RIDEM Preliminary Determination Submission

Richmond Hills - Phase 3

Located on Ellen Brady Drive
 Richmond, Rhode Island
 Assessor's Plat 7D Lot 9

GRADING PLAN
Richmond Hills - Phase 3
 ASSESSOR'S PLAT 7D LOT 9
 RICHMOND, RHODE ISLAND

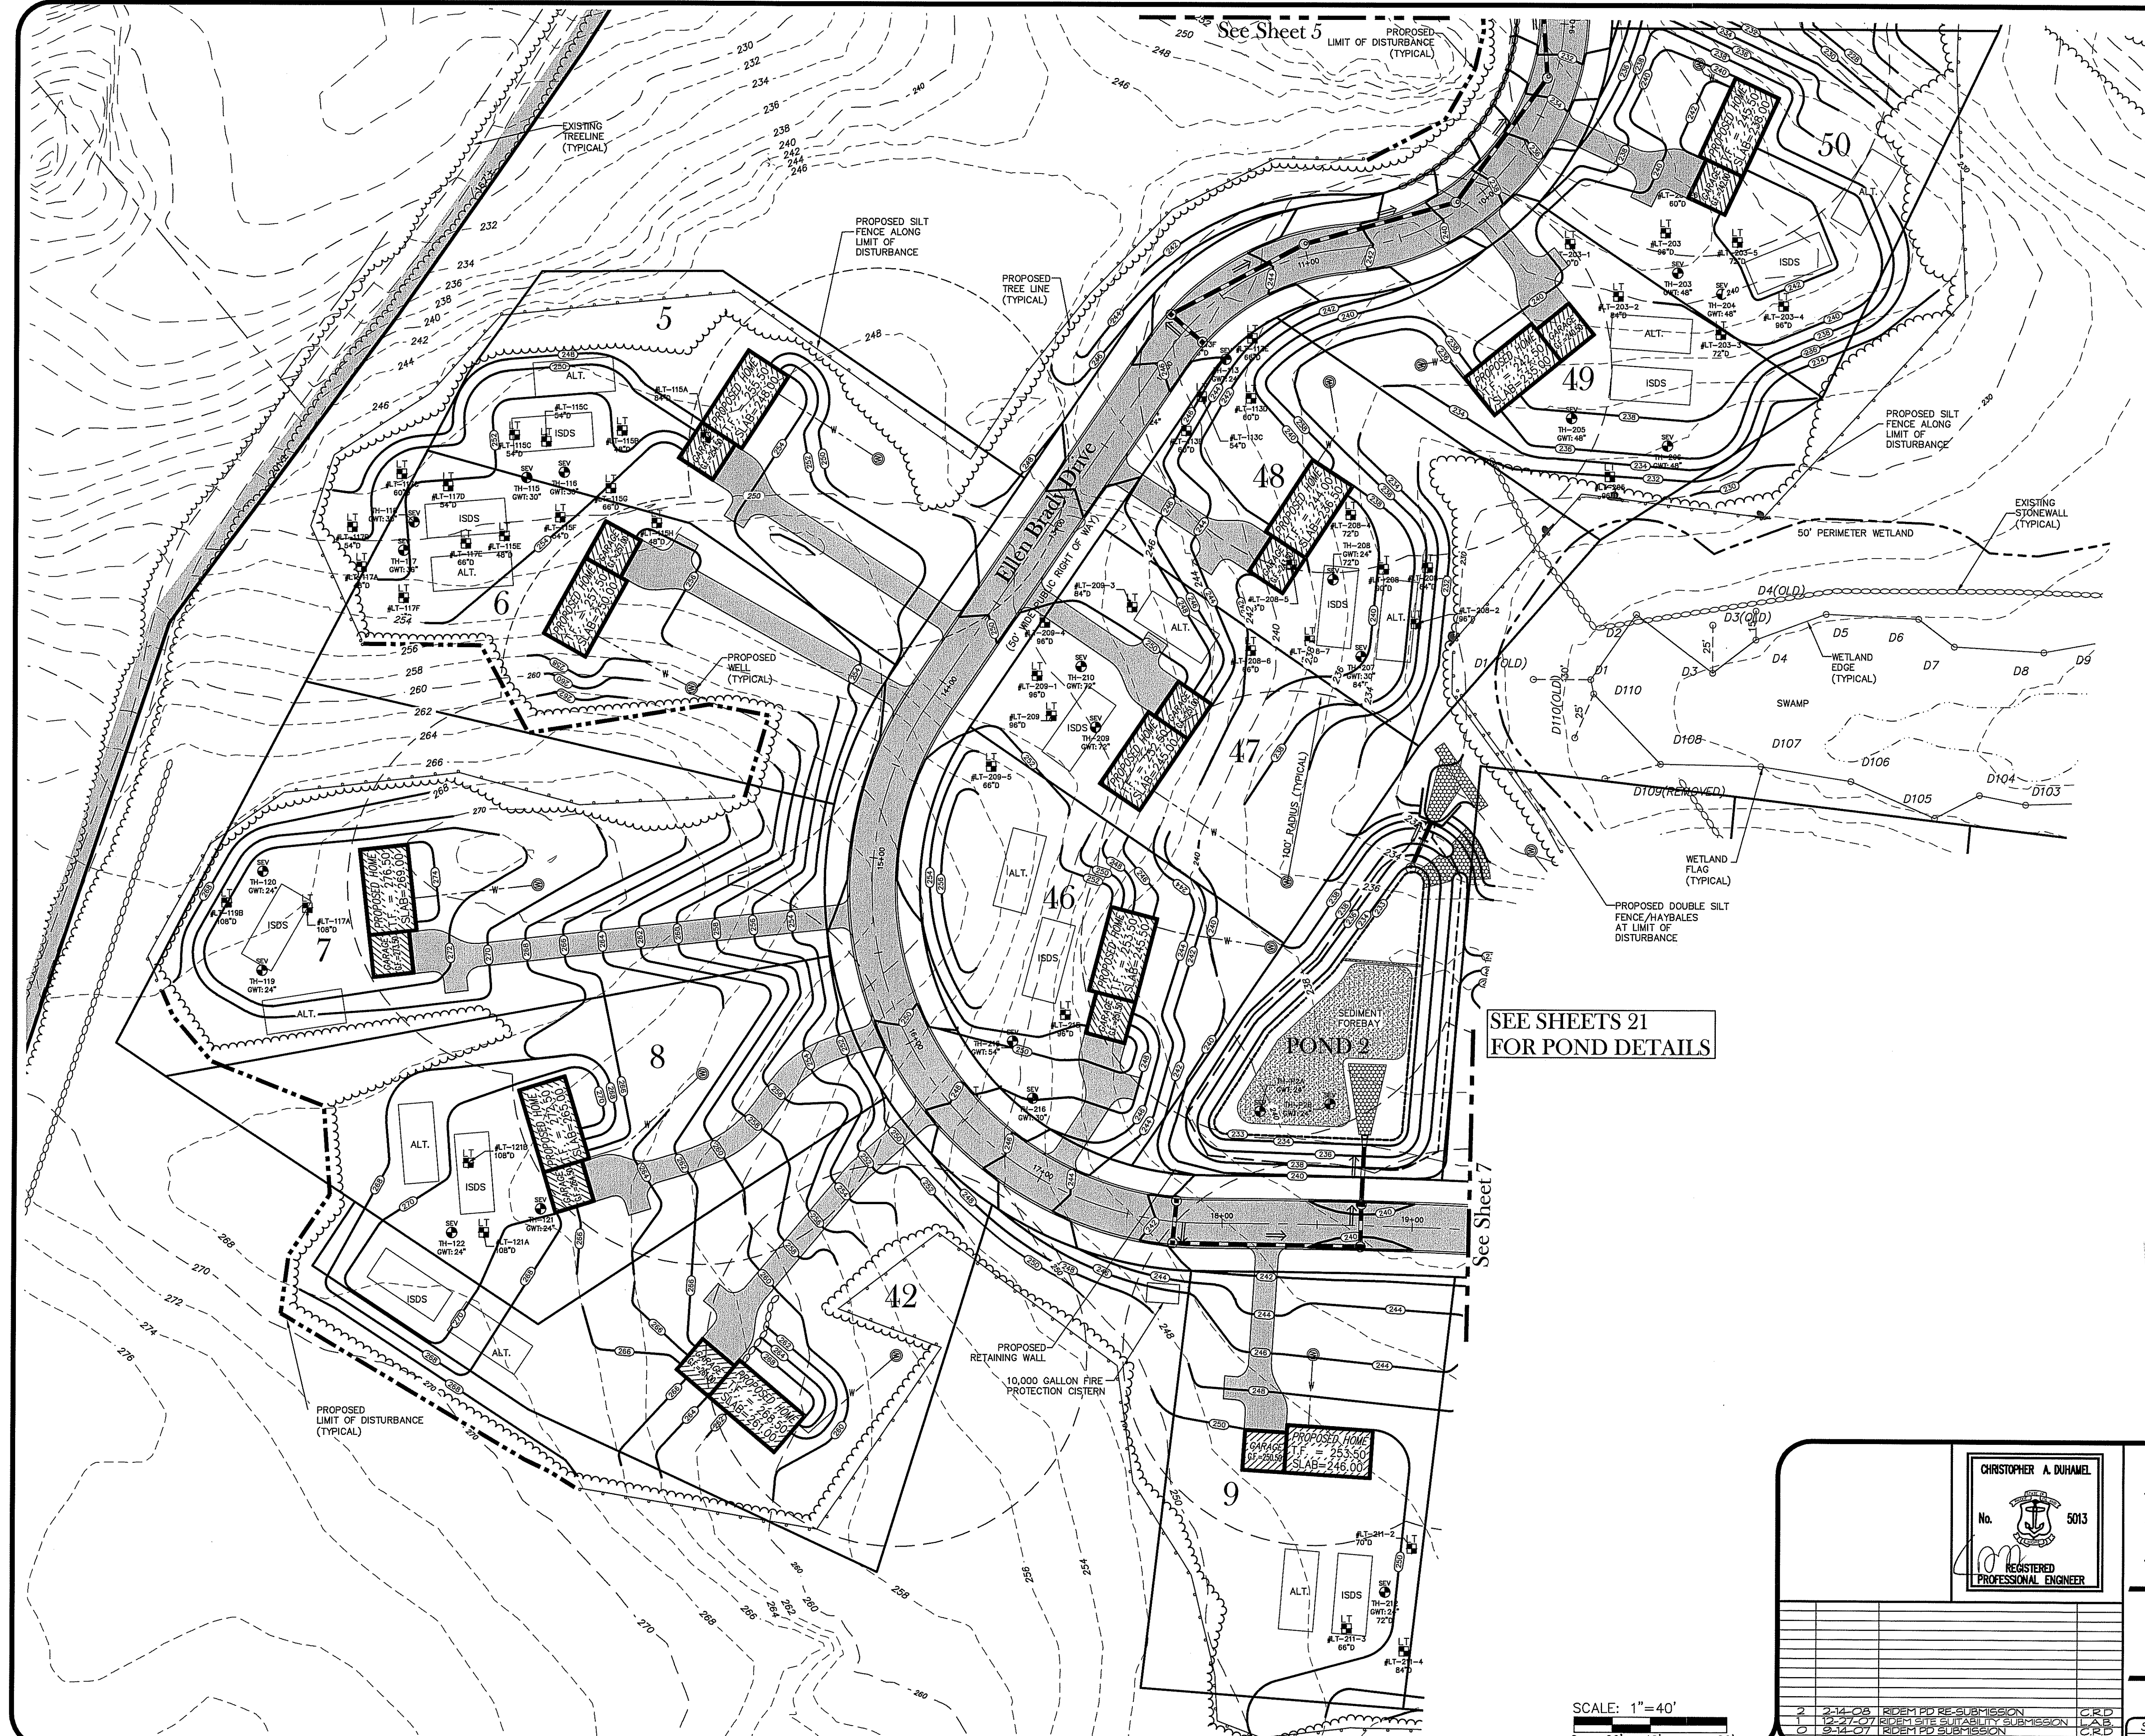
Per RIDEM:
Install permanent buffer zone
markes according to Permit Condition
No. 11.
